TITLE: SPECIAL PERMIT NO. 04011, BOULDER RIDGE COMMUNITY UNIT PLAN, requested by Lyle Loth of ESP on behalf of Glen Herbert, for 461 dwelling units, consisting of 189 single family units, 48 single family attached units and 224 multiple family units, with an additional 240 unassigned units, on property generally located at South 84th Street and Pine Lake Road.

LINCOLN CITY/LANCASTER COUNTY PLANNING STAFF REPORT

P.A.S.: Change of Zone #04017
Special Permit #04011

To:	Tom Cajka, Planning Department
From:	Chad Blahak, Public Works and Utilities Dennis Bartels, Public Works and Utilities
Subject:	Boulder Ridge Preliminary Plat #04008 and Special Permit #04011
Date:	5/06/04
cc:	Randy Hoskins

BOULDER RIDGE

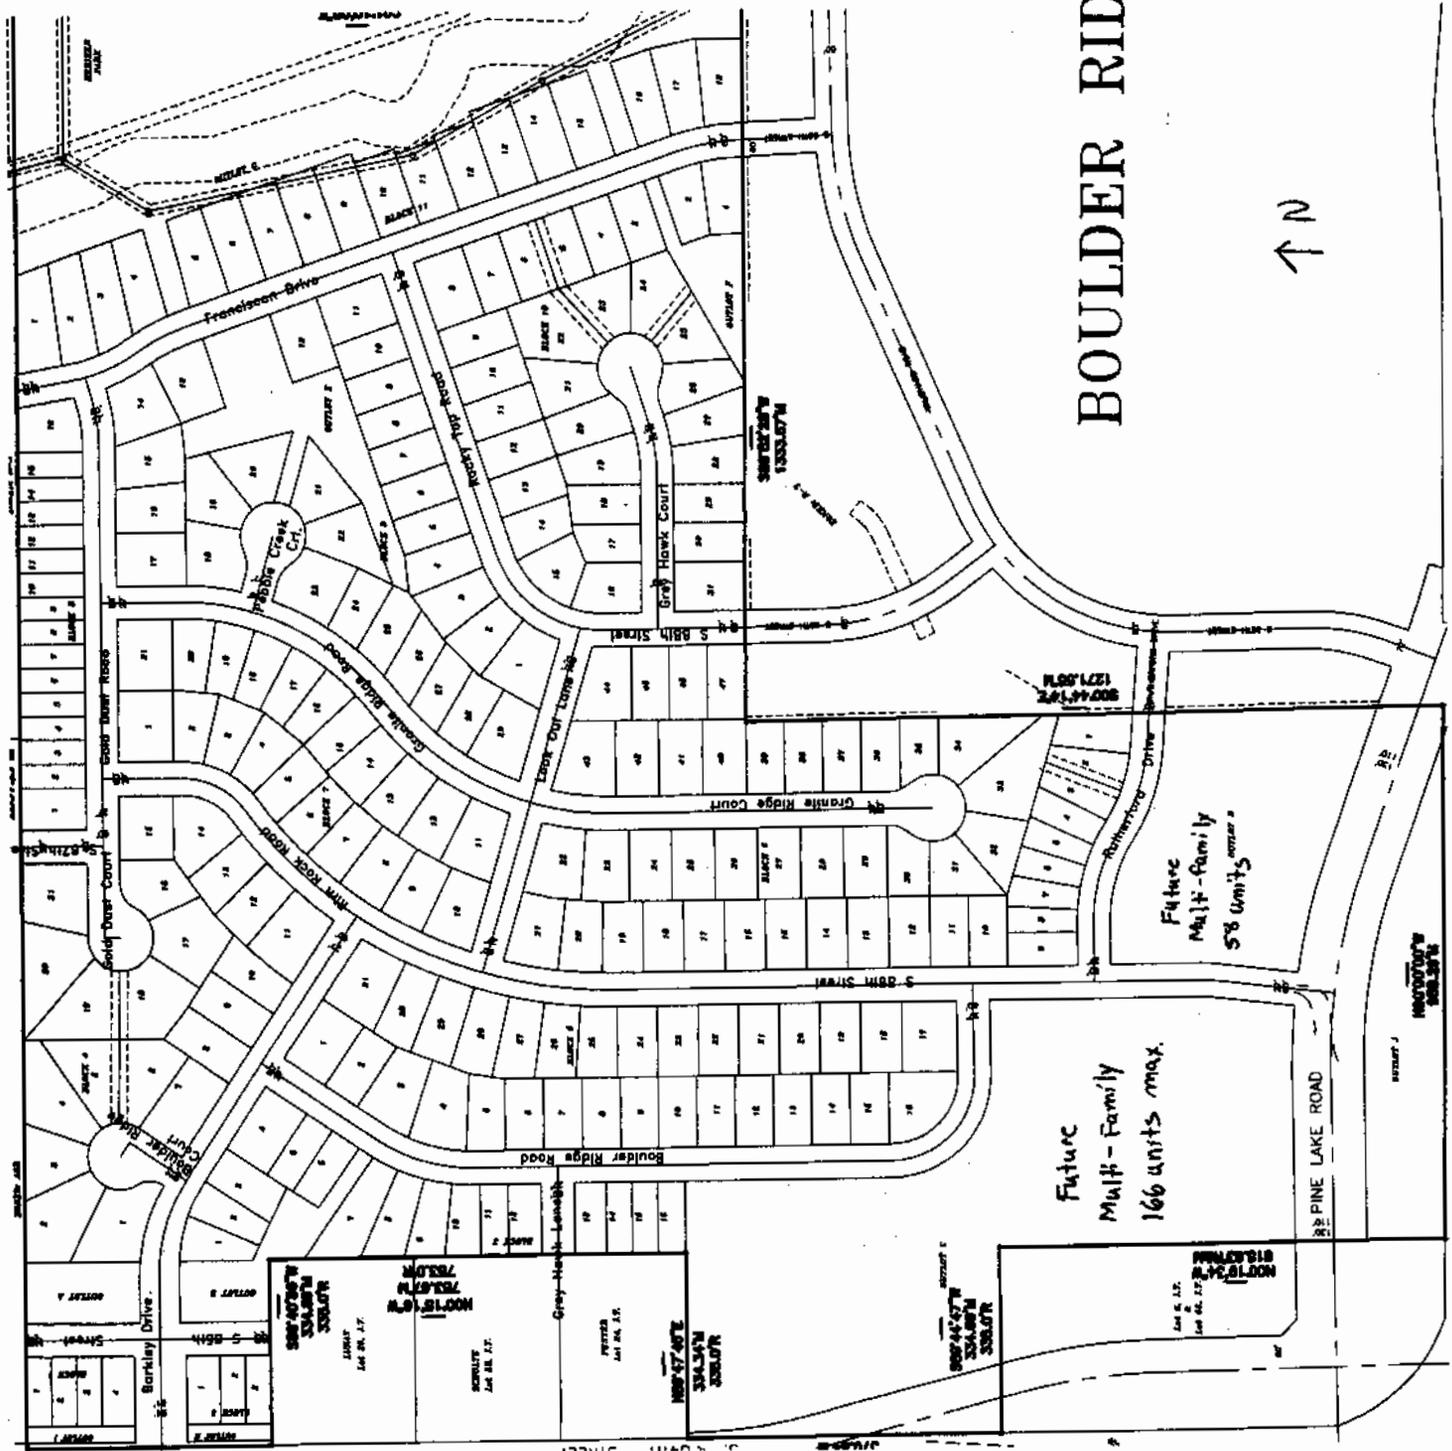
- 1.1 Revise the site plan to show:
- 1.1.1 a fire hydrant on Granite Ridge Rd. between Look Out Lane and Pebble Creek Cir.
 - 1.1.2 ~~Show a street from S. 85th St. or Boulder ridge Rd. to provide access to Lot 64 I. T. and Lot 66 I. T. Include a Note that reasonable access to Lot 6 I.T. and Lot 66 I.T. shall be provided at the time of multi-family site plan approval, to the satisfaction of the Public Works & Utilities Department. (**Per Planning Commission, at the request of the applicant, 06/09/04**)~~

- 1.1.3 a conceptual street lay out for Lots 23-25 I. T.
 - 1.1.4 ~~Outlot I combined with Lots 1-4, Block 1. (**Per Planning Commission, as recommended by staff, 06/09/04**)~~

- 1.1.5 ~~Outlot H combined with Lots 1-3, Block 2. (**Per Planning Commission, as recommended by staff, 06/09/04**)~~
 - 1.1.6 ~~Granite Ridge Ct. extended to Rutherford Dr. (**Per Planning Commission, at the request of the applicant, on a vote of 6-2, 06/09/04**)~~

- 1.1.7 the existing house on Lot 16 I.T.
 - 1.1.8 revise note 13 . change 227 to 224 multi-family units and change 9 outlots to 10 outlots.
 - 1.1.9 change total unassigned units to 240 in the density calculations table

- 1.1.10 revise note 16 to state Outlots C & D will be maintained by the developer.
 - 1.1.11 revise the legal description and boundary of the plat.
 - 1.1.12 show a pedestrian easement over the sanitary sewer easement from Grey Hawk Ct. to Franciscan Dr.

- 1.1.13 change the note in the northwest corner of the plat to read, "10' of additional ROW to be dedicated to the City."
 - 1.1.14 corrections per Public Works & Utilities Department memo of May 6, 2004, except that a median in Barkley Drive shall be permitted east of 84th Street with a median opening for So. 85th Terrace and Court. (**Per Planning Commission, at the request of the applicant, 06/09/04**)

- 1.1.15 the outlot designation for the multiple family to lot
- 1.1.16 a new block for the lots south of Grey Hawk Ln. Outlot "C" must be changed to a lot and included in this block.

(1.1) There are a number of locations where the sewer is to run opposite street grades, requiring a waiver of design standards. Public Works would approve this waiver provided that maximum depths are not exceeded as a result of the waiver. Information needs to be provided showing the locations where the waiver applies and showing that the maximum 15' depth is not exceeded.

(3.1) Show the grading for the new 84th Street and how the proposed site grading along 84th will match these grades.

(3.2) There are numerous locations on the grading plan that show excessively flat lots or show drainage flowing down shared rear lot lines. As lots in these areas are built upon, the assumed drainage paths are frequently blocked during the home construction process causing drainage problems for the future home owner. Public Works recommends that the grading plan be revised to show a minimum of 3% slope from rear to front on all lots. Blocks 5, 7, 9, and 10 show lots with these potential drainage problems.

(3.3) Drainage swales are required for conveyance of the 100yr flow between Lots 20-21 Block 9 and between Lots 24-25 Block 10. Typical cross sections and capacity calculations need to be shown. The grading plan needs to be revised to match the cross sections provided.

(3.4) The location of the proposed 42" storm sewer between Lots 4&5 Block 11 with respect to the proposed sanitary sewer is unsatisfactory. Design standards state that a minimum of 10' separation needs to be provided between sanitary sewer and storm sewer. The site plan and utility plan need to be revised to meet design standards.

(3.5) The grading plan shows grading outside of this plat at the north end of 85th Street and 87th Street. Written proof must be provided stating the this developer has permission to grade on the adjacent property to the north or the grading plan needs to be revised to show no grading outside

(3.6) The 100yr flood elevations are shown on the grading plan, however, no supporting information has been provided as previously requested. Given the proximity of proposed lots to the Antelope Creek Floodway, supporting calculations and documentation needs to be provided for the flood elevations shown.

(3.7) The minimum elevations shown for lots in Block 3 should be revised to 1381.75. This elevation represents the approximate emergency overflow elevation for the proposed detention pond. All other minimum opening elevations need to be revised to 1' above the 100yr elevations shown for the proposed detention ponds and along Antelope Creek as per design standards.

(3.8) There appears to be an error on the grading plan concerning the proposed storm sewer that is shown between Lots 4&5 Block 11. The plan shows a 42" pipe draining to a 36" pipe. One or both of the pipe size labels needs to be revised to match the correct size indicated in the drainage study.

(4.1) The site plan shows portions of Barkley Drive between South 85th Street and Boulder Ridge Court to have approximately 6' of separation between the back of curb and the ROW line. This is unsatisfactory. If a wider street section is to be constructed the ROW needs to be widened appropriately providing the standard 16.5' from back of curb to ROW line to allow for the construction of water mains, sanitary sewer, and other utilities that are typically located in this area. Also, the median in Barkley Drive creates poor alignment with the existing Barkley Drive on the west side of 84th.

(4.2) The intersection of South 86th Street and Pine Lake Road is shown to have left in and no left out. This intersection configuration is not approved by Public Works as they do not appear necessary and may cause an insufficient left turn pocket length in Pine Lake Road and should be revised to show a full median across the intersection.

(4.3) The intersection of Barkley Drive and 84th Street as shown would require a waiver of design standards for maximum grade on the approach to a major street. This waiver has not been requested and justification has not been provided. The profile for Barkley Drive needs to be revised to show the proper platform length unless sufficient justification is provided and approved by Public Works.

(4.4) The intersection at 85th and Barkley Drive as shown would require a waiver of design standards for maximum grade of 3.0% on the approach to an intersection. This waiver has not been requested and justification has not been provided. The profiles need to be revised to show the proper platform length unless sufficient justification is provided and approved by Public Works.

(4.5) Right turn lanes need to be shown in Pine Lake Road at 86th Street and in 84th Street at Barkley Drive. The right turn lanes are not impact fee facilities and should the responsibility of this developer.

(4.6) The dimension note in the north west corner of the plat concerning the 10' of future ROW needs to be revised to say "10' of additional ROW to be dedicated to the city".

Carroll moved to amend Condition #1.1.14 to add language, "...except that a median in Barkley Drive shall be permitted east of 84th Street with a median opening for So. 85th Terrace and Court.", seconded by Sunderman.

Carroll moved to amend Condition #1.1.2 as requested by the applicant, adding, "to the satisfaction of the Public Works & Utilities Department"., seconded by Marvin.

Larson moved to amend to delete Condition #1.1.6, seconded by Sunderman.

Larson moved to amend to delete Condition #1.1.12, as requested by the applicant, seconded by Sunderman.
